# Planning Authority Agenda

## 5.1 Development Application DA 2021 / 00274 - Equipment and Machinery Hire (Storage Containers) at 77 Possum Road, Bridgewater

Applicant:	MCA Architects Pty Ltd
Subject Site:	77 Possum Road, Bridgewater
Proposal:	Equipment and Machinery Hire (Storage Containers)
Planning Scheme:	Tasmanian Planning Scheme - Brighton
Zoning:	General Industrial Zone
Codes:	Signage Code Parking and Sustainable Transport Code Road and Railway Assets Code
Local Provisions:	Brighton Industrial Hub Specific Area Plan Bridgewater Quarry Specific Area Plan
Use Class:	Equipment and Machinery Sales and Hire
Discretions:	Building Height Frontage Setback Landscaping Number of Car Parking Spaces Construction of Parking Areas Pedestrian Access Traffic Generation Design and Siting of Signs Bridgewater Quarry Specific Area Plan
Representations:	One (1) representation was received. The representors raised the following issues: <ul style="list-style-type: none"> <li>• Application is poor quality and unclear</li> <li>• Advertised material does not contain adequate information</li> <li>• Building height</li> <li>• Frontage setback</li> <li>• Landscaping</li> <li>• Signs Code</li> <li>• P

DWG NO. C01	REVISION P1
-------------	-------------

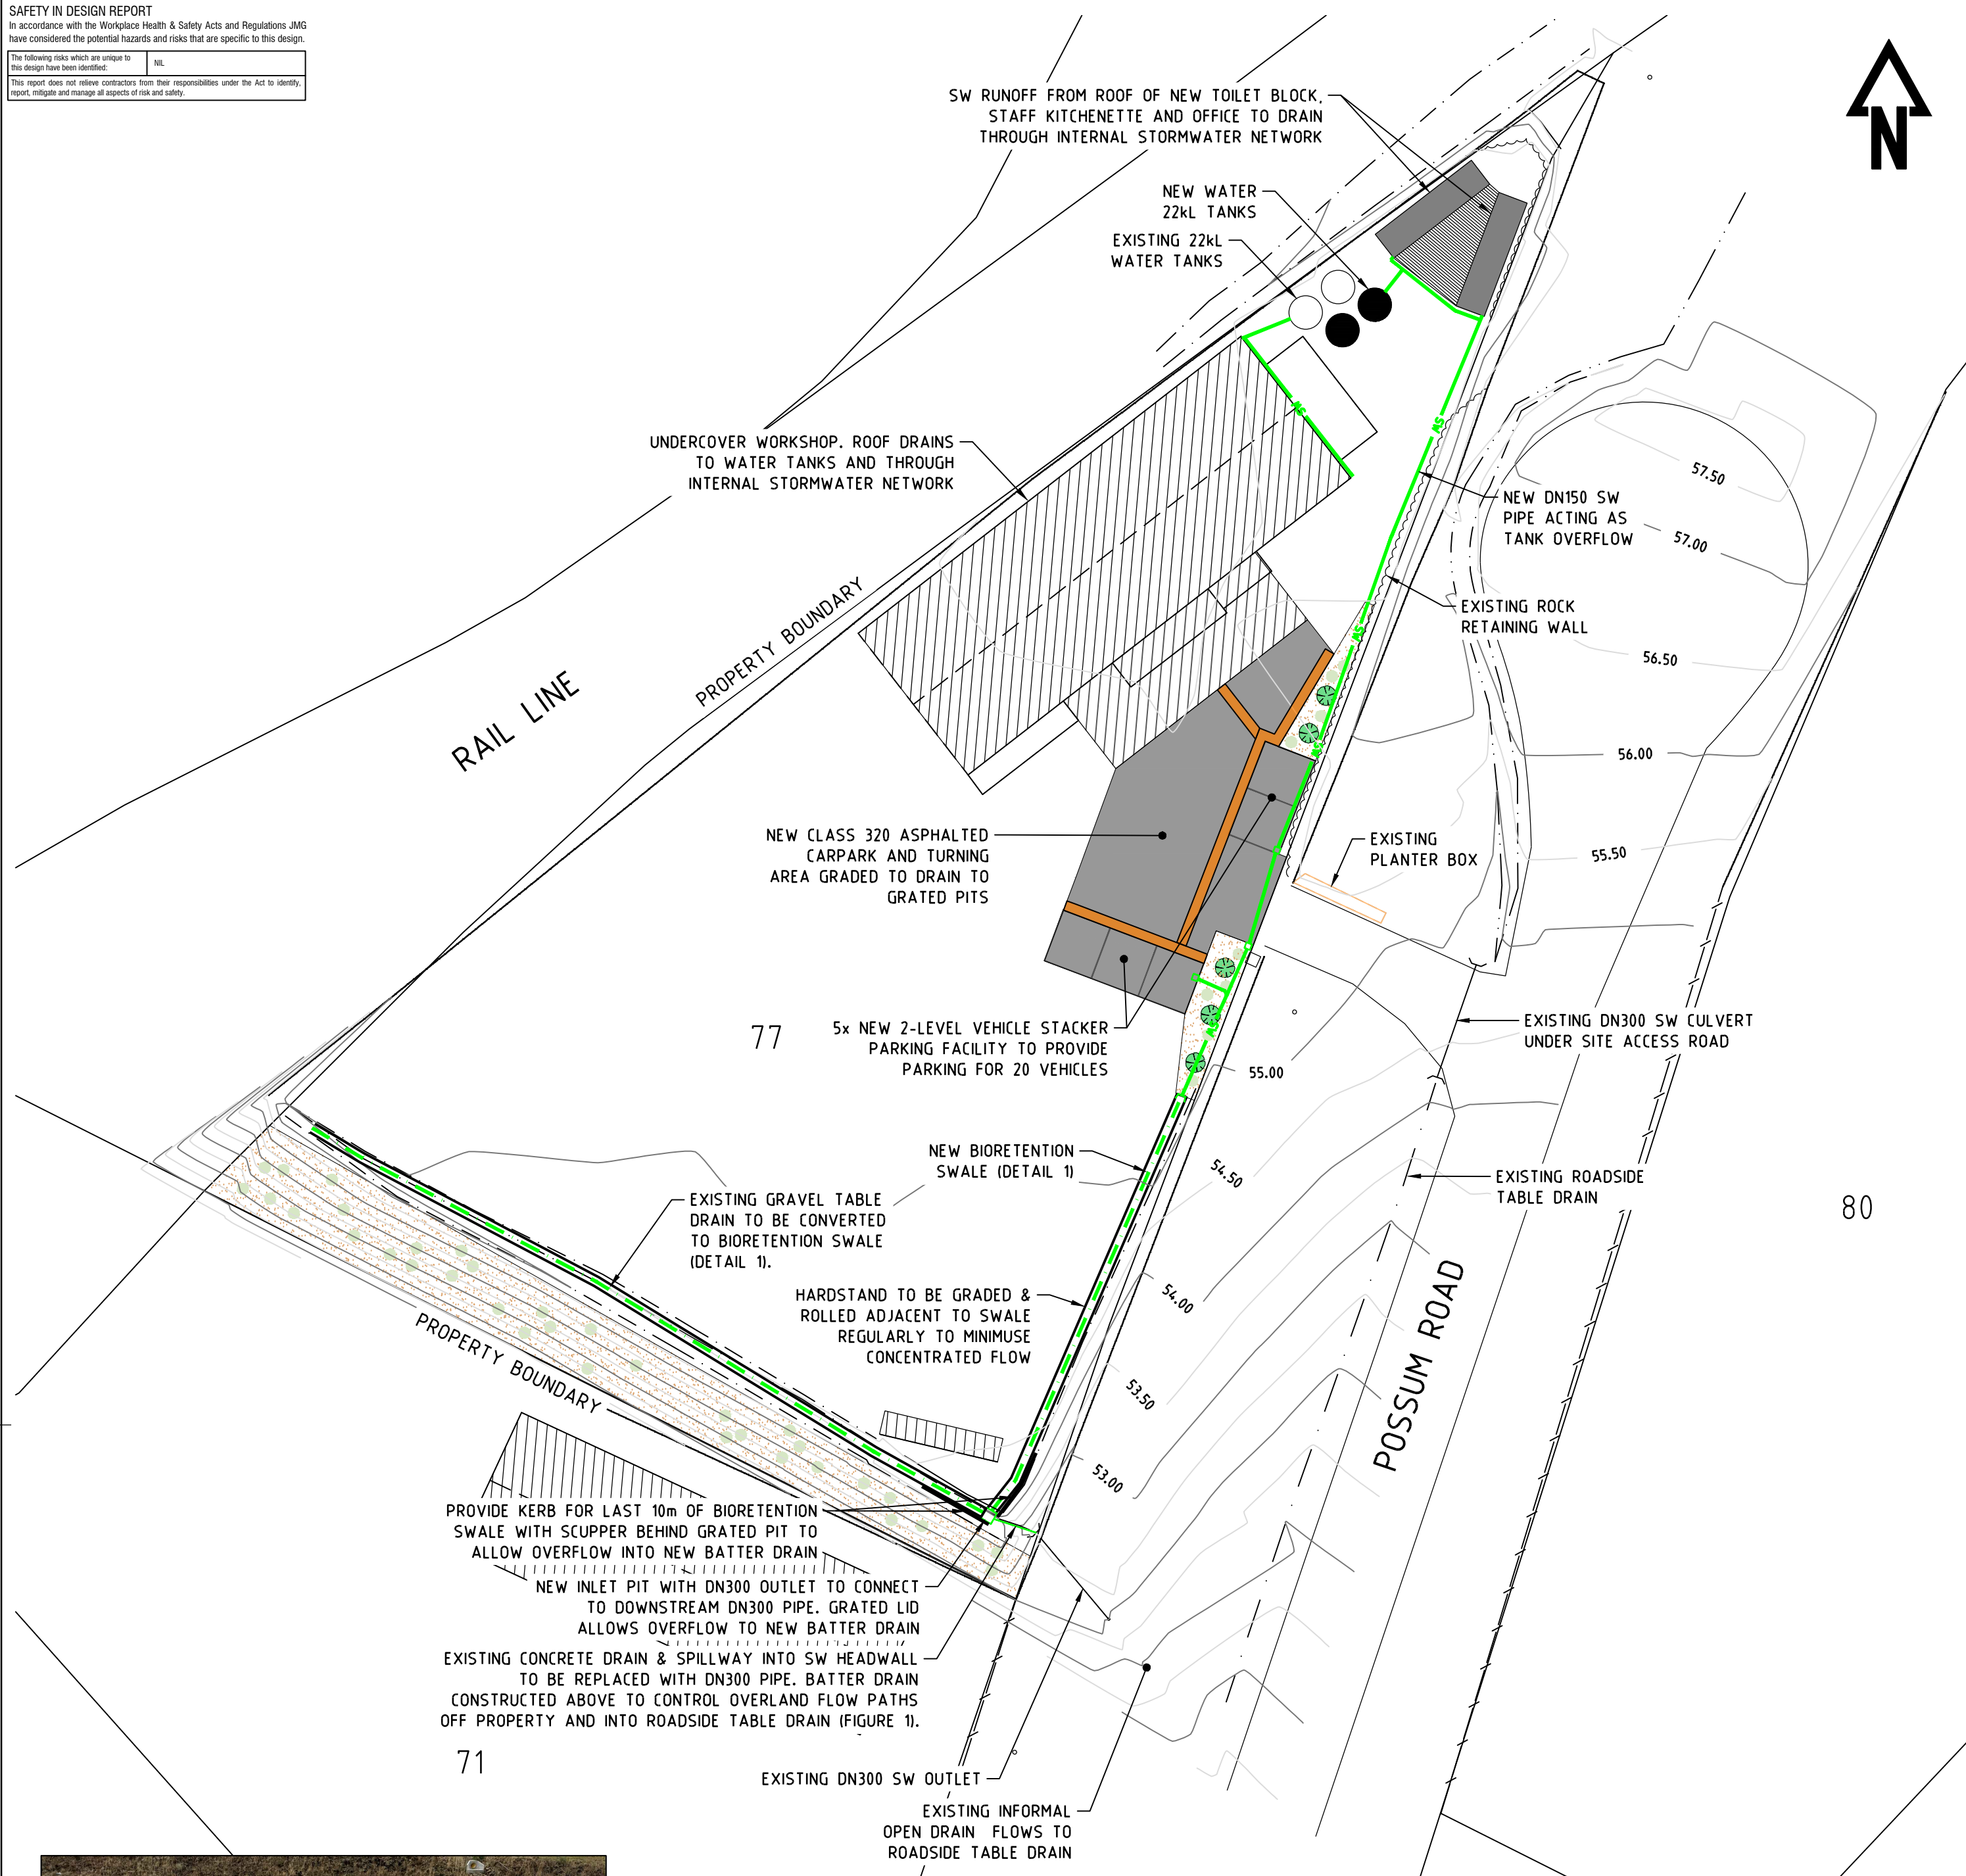
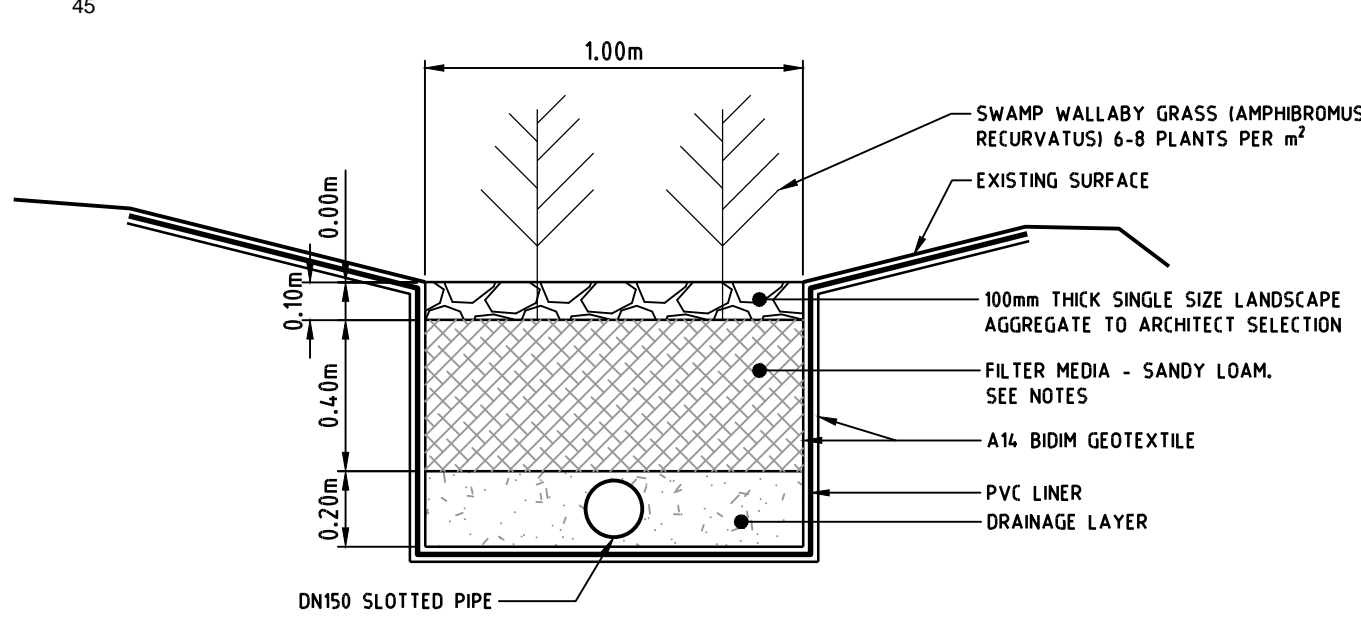
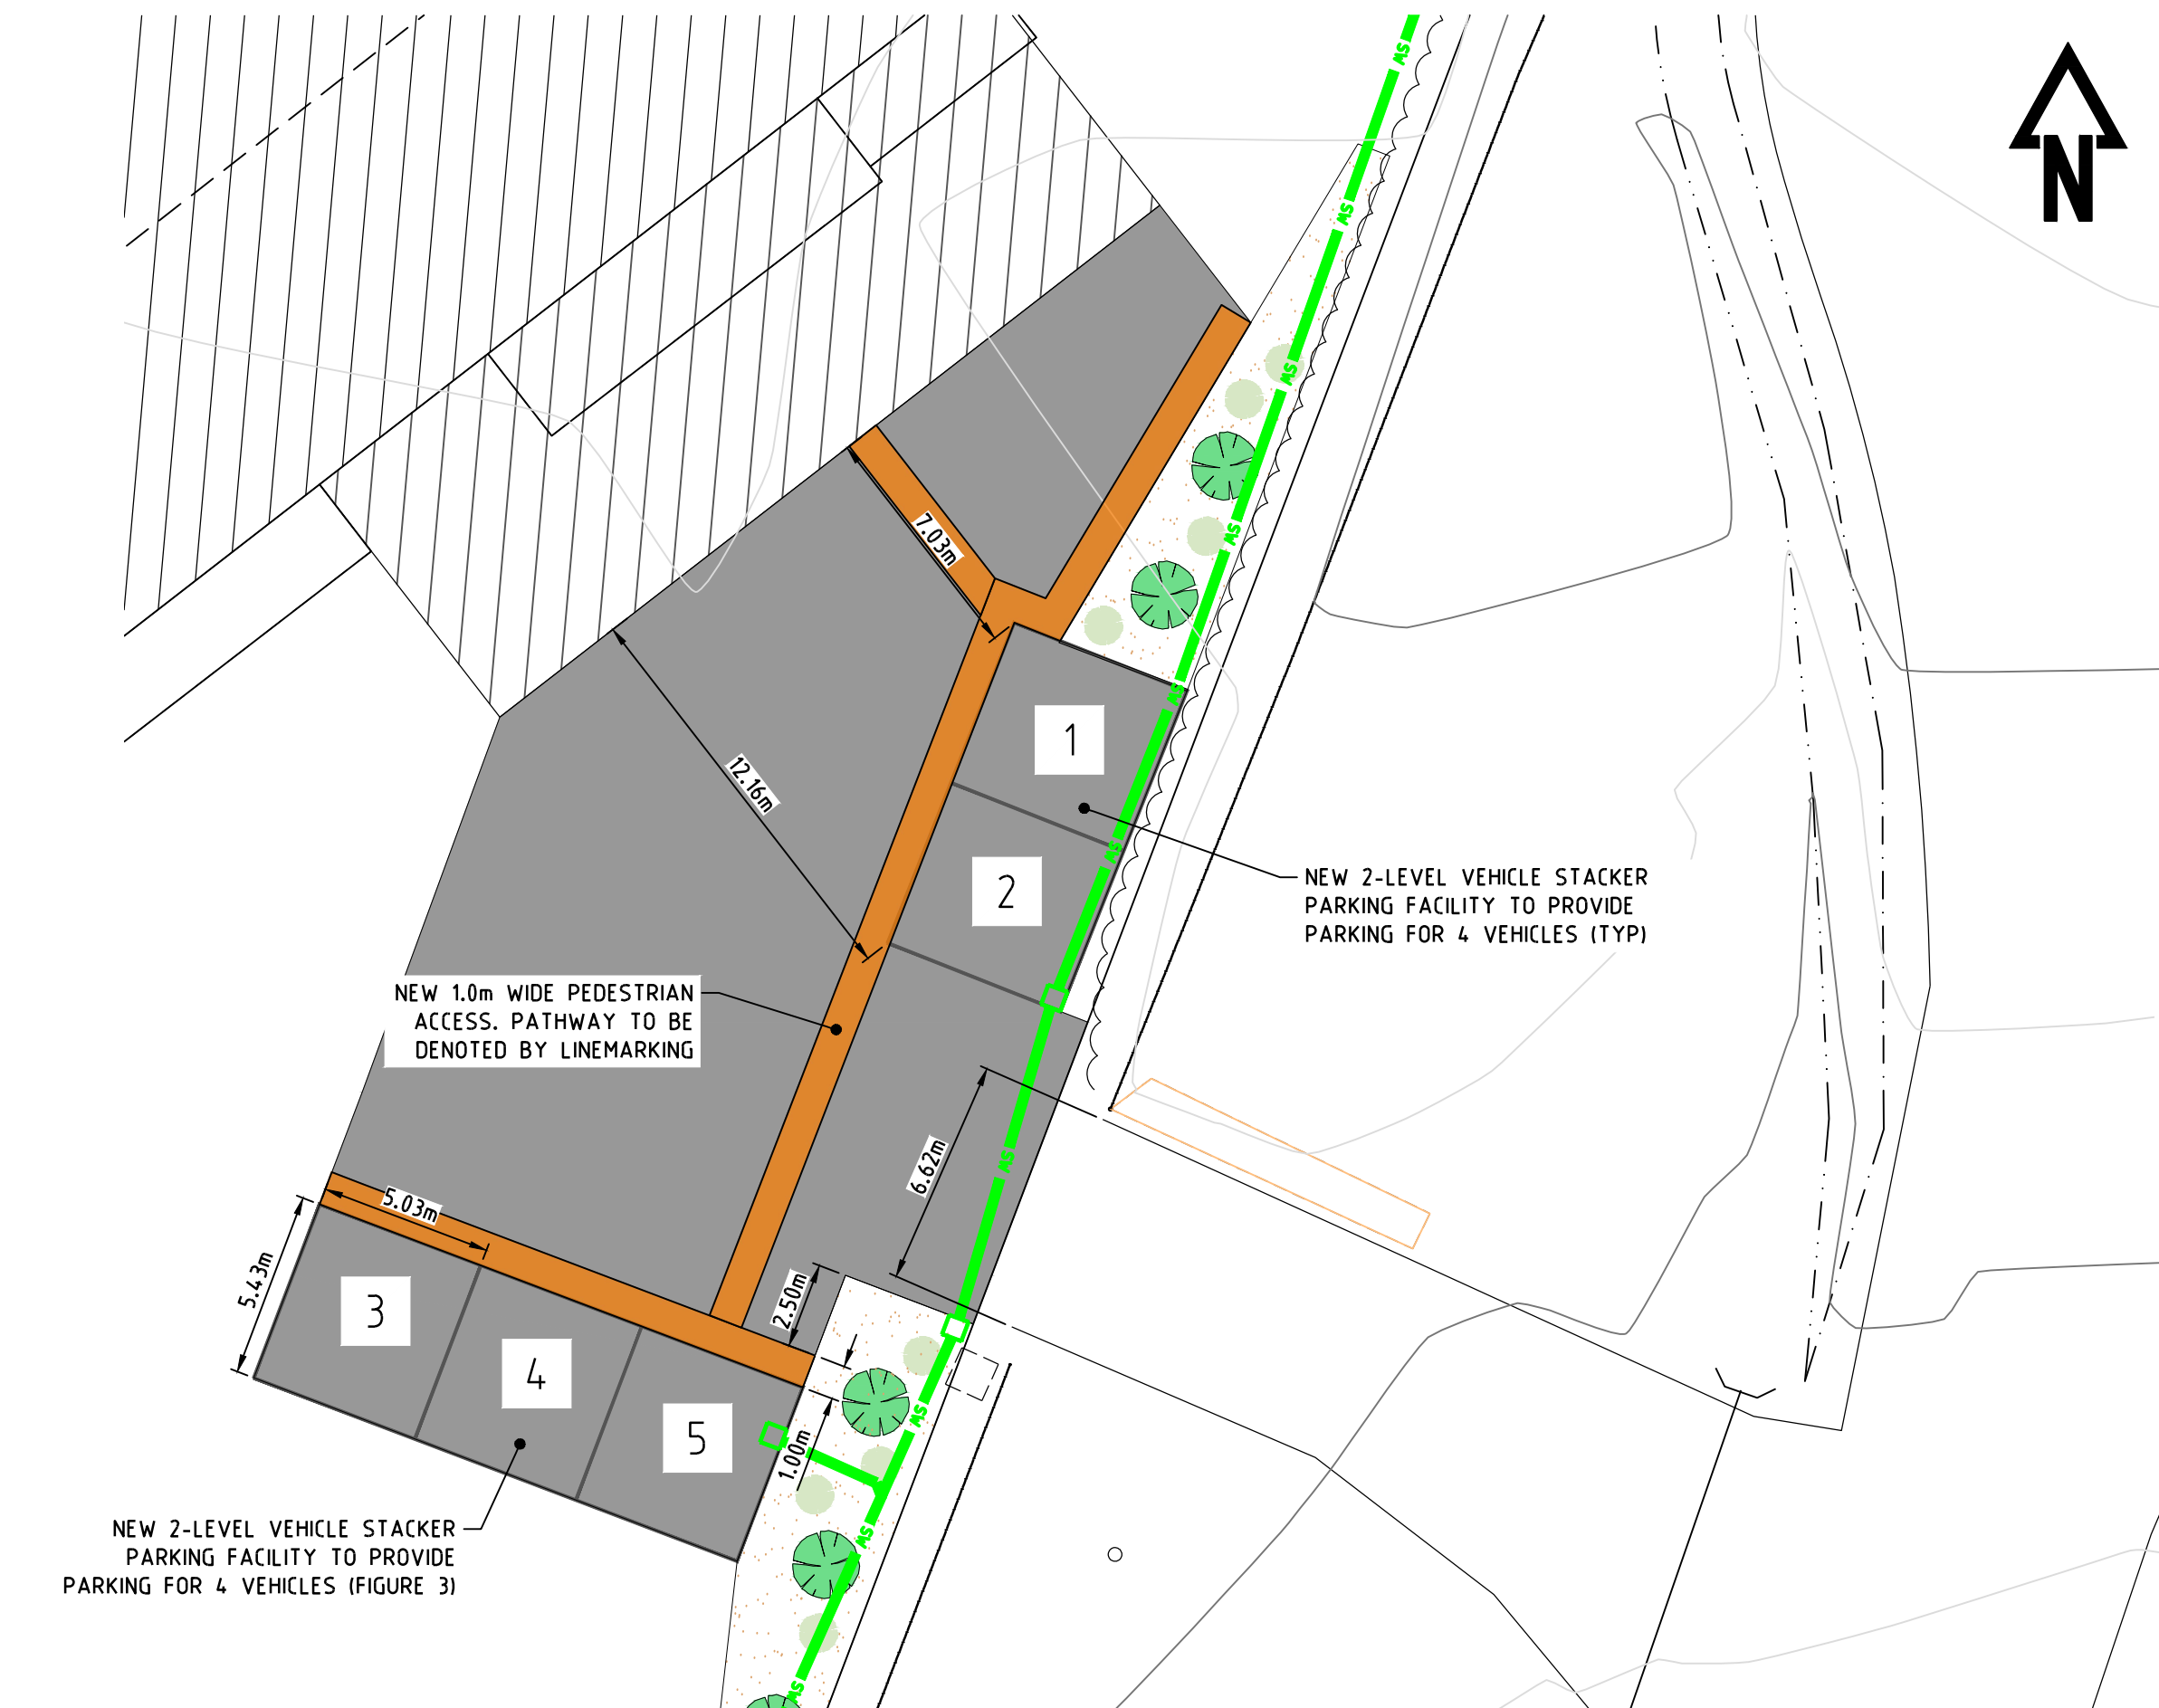
Table C2.1 of the scheme requires that the proposed development include a minimum of 24 car parking spaces based on the floor area of the buildings proposed. The proposal documents show 20 car parking spaces, to be created through the use of vehicle stackers (refer sheet C01) and Traffic Impact Statement (Midson, 2022).

The proposal was referred to council's senior technical officer who has considered the application documents, including the TIS. That officer has determined that there is sufficient room on site to accommodate the necessary car parking spaces. Accordingly, it is recommended that a condition requiring the minimum amount of car parking spaces (24) and requiring the preparation of a parking plan be included in any permit granted.

21. Within one (1) month of the date of this permit and prior to the lodgement of building or plumbing applications required pursuant to *the Building Act 2016*, the developer must submit to Council a parking plan including:
